Application for Licence Amendment

Licence Number L5850/1993/11

Premises Koolyanobbing Mine

Date of Report 24 May 2024

Figure 1: Environmental receptors in relation to the location of infrastructure proposed to be installed at the Premises.

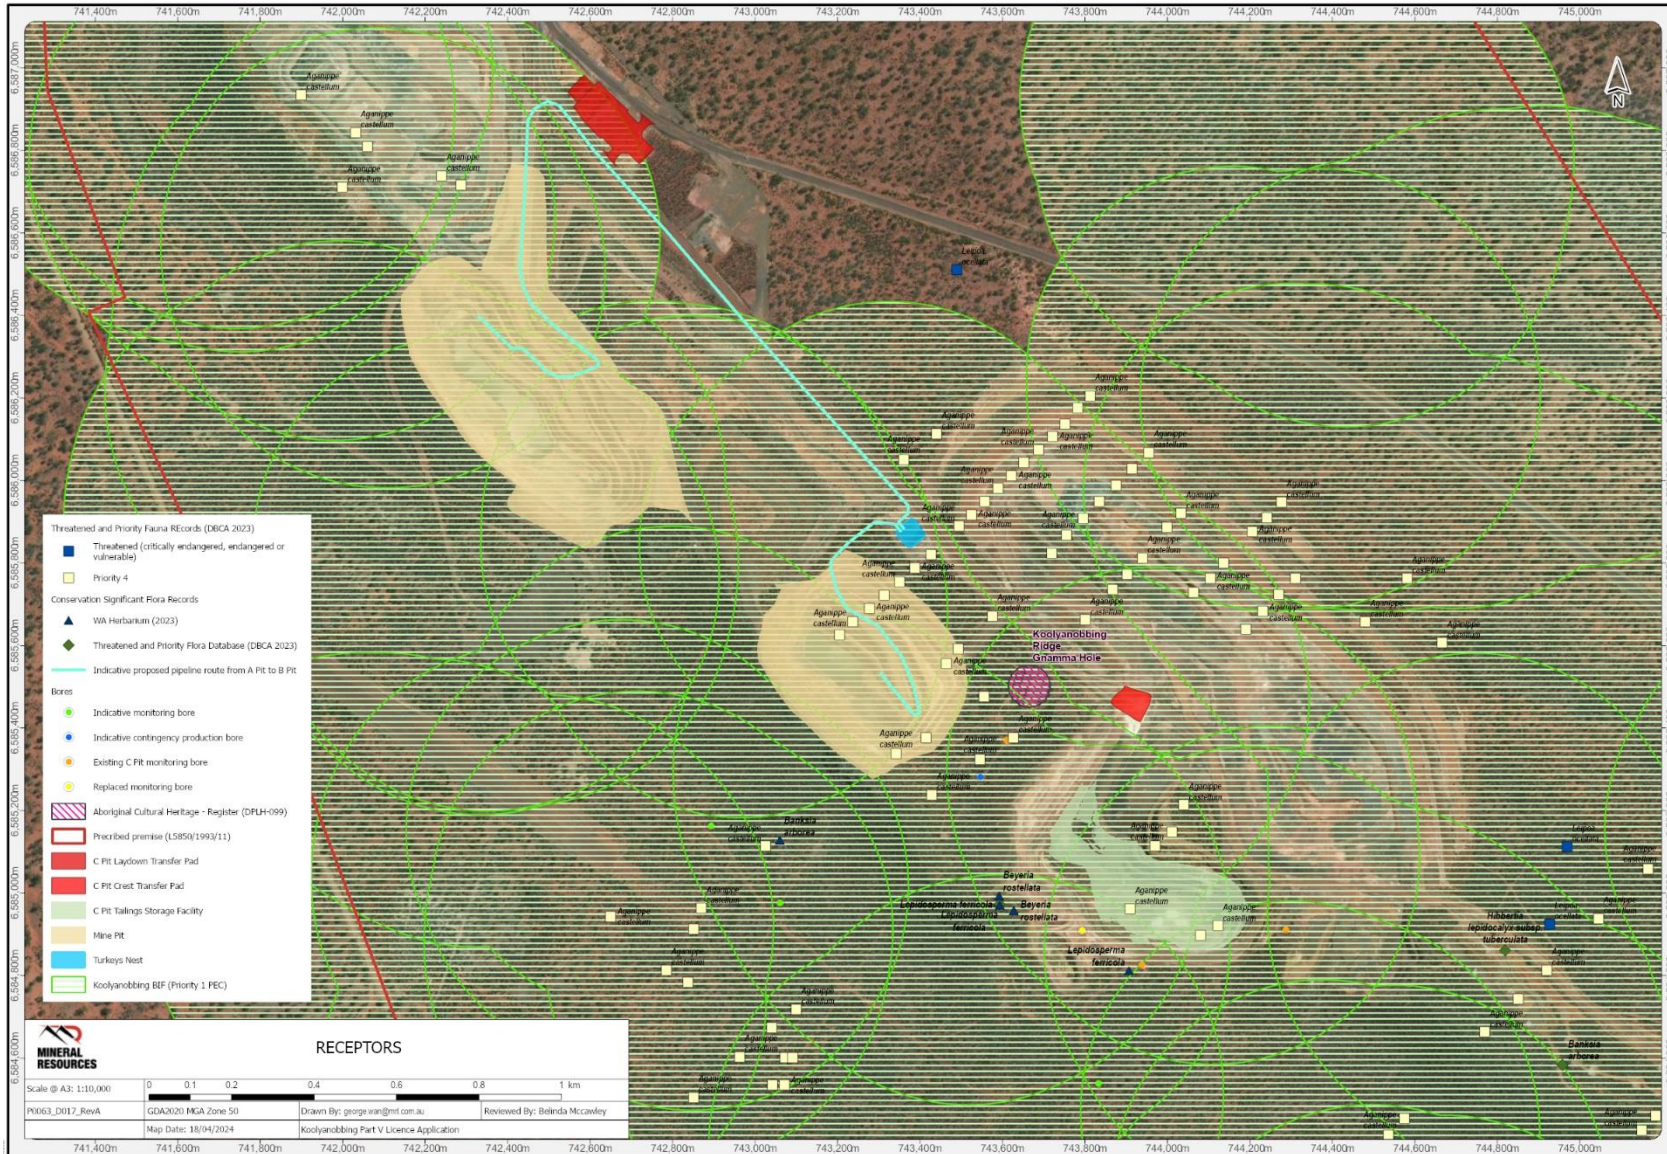
Figure 1 DWER comment 5: UPDATE WITH CATEGORY 6 (MINE DEWATERING INTO B PIT)	A replacement map was provided with the application showing the prescribed premises boundary and all infrastructure relevant to the prescribed premises (including A pit and B pit). This has been further refined in response to other comments from DWER in the draft amendment package (attached).	Figure 1 updated.

<p>2.3.1: Mining Proposal</p> <p>DWER comment:</p> <p>THE SUPPORTING DOCUMENT MAKE REFERENCE TO THE FOLLOWING APPROVALS UNDER PART IV. PLEASE CLARIFY THEIR RELATION TO THE CURRENT APPLICATION (IF ANY).</p>	<p>Ministerial Statements MS 982 and MS 1133 have no direct relation to the current application and are provided for approval context only. Some of the environmental management plans pertaining to MS 982 are implemented voluntarily across the entire Yilgarn Operations, including Koolyanobbing.</p>	<p>Added section 2.3.2 Part IV of the EP Act to discuss the voluntary implementation of the Dust Management Plan and monitoring of vegetation. See comment two rows below.</p>
<p>2.3.2: Figure 1</p> <p>DWER comment 9:</p> <p>FIGURE TO BE UPDATED OR ADDITIONAL FIGURE TO BE PROVIDED TO INCLUDE ENVIRONMENTAL RECEPTORS: E.G. PEC, CONSERVATION PRIORITY FLORA, GNAMMA HOLE, AND CONSERVATION PRIORITY FAUNA.</p>	<p>New Figure "Receptors" provided.</p>	<p>Updated Figure 1.</p>
